## Response to Additional Information Request

For DA2022/1799 under PAN-274147  
11 Coutts Crescent, Collaroy NSW 2097  
Lot 47, DP 236457,

Photograph below showing peg out of the Council's stormwater pipelines carried out by a service locating contractor as requested.

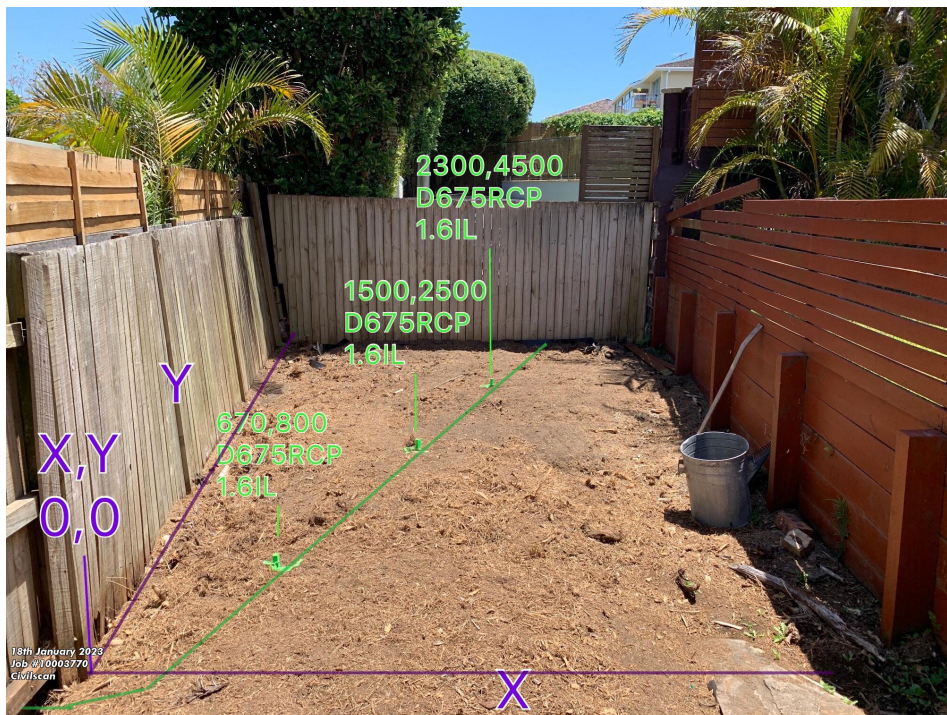
*'Council's records indicate the subject property is burdened by a 675 mm diameter Council stormwater pipeline which traverses across the site near to the proposed swimming pool. The applicant must provide the accurate location of the pipeline and plot to Council's stormwater pipelines and associated infrastructure on the DA site plans that outline the proposal. This should be carried out by a service locating contractor and registered surveyor to confirm the information of the pipeline.'*

The updated Survey plan has been amended to accurately locate & plot Council's stormwater pipelines and associated infrastructure on the Survey.

*The updated DA 01 Site Plan shows the location of the Council's stormwater pipelines and associated infrastructure.*
